Product Change Notice (PCN)

PCN Number: PCN-0456242R-02

Product(s) Affected: *SJ1-353XNS Series (SJ1-3533NS, SJ1-3534NS, SJ1-3535NS)*

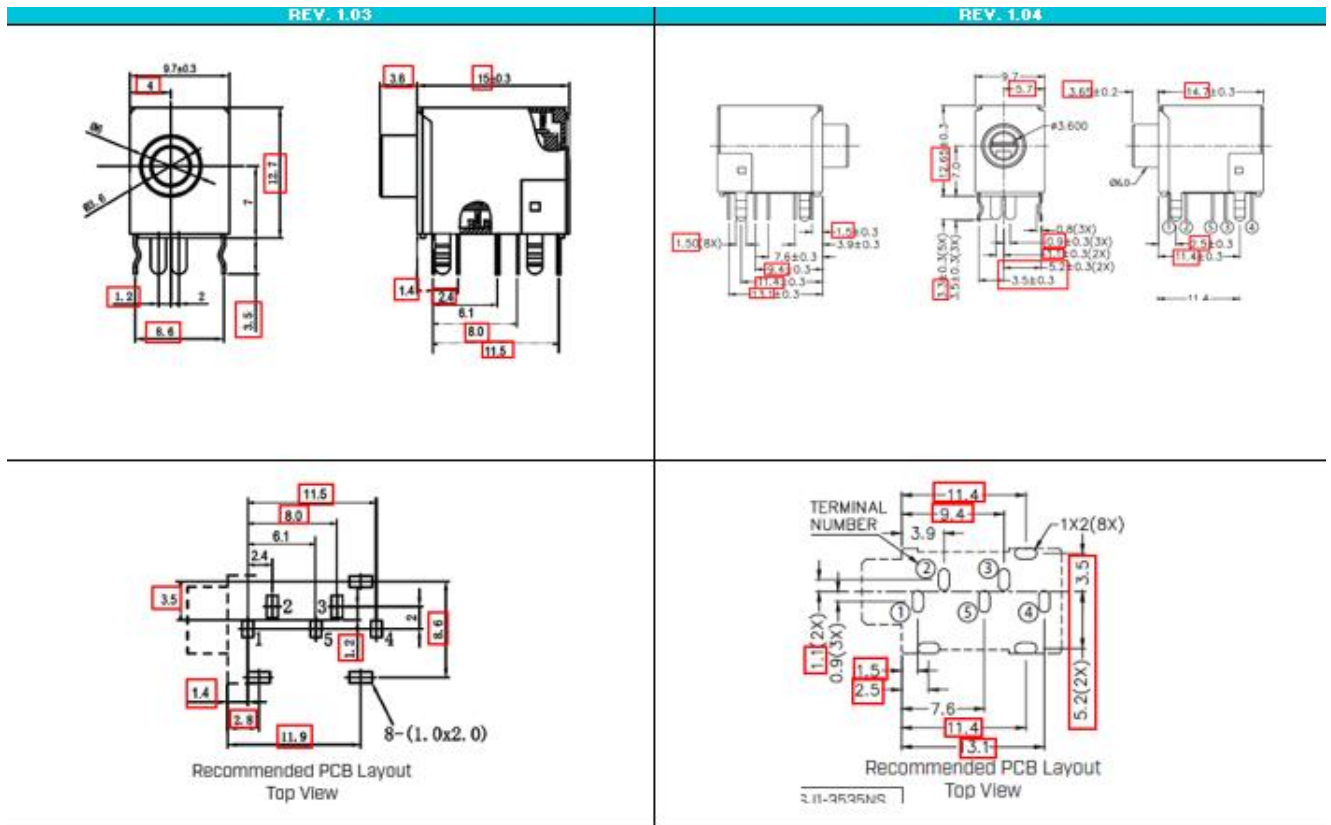
Description of Change: *Minor Layout and Material Difference. See image Below*

DESCRIPTION	MATERIAL	PLATING/COLOR
terminal 1	brass	silver
terminal 2	phosphor bronze	silver
terminal 3	phosphor bronze	silver
terminal 4	brass	silver
terminal 5	brass	silver
spring	stainless steel	nickel
bushing	brass H58	nickel
shield	SPCC t=0.30	nickel
housing	PBT (UL94V-0)	black

DESCRIPTION	MATERIAL	PLATING/COLOR
terminal 1	brass	tin
terminal 2	brass	tin
terminal 3	brass	tin
terminal 4	brass	tin
terminal 5	brass	tin
spring	stainless steel	
bushing	brass	nickel
shield	cold rolled steel	nickel
housing	PBT (UL94V-0)	black
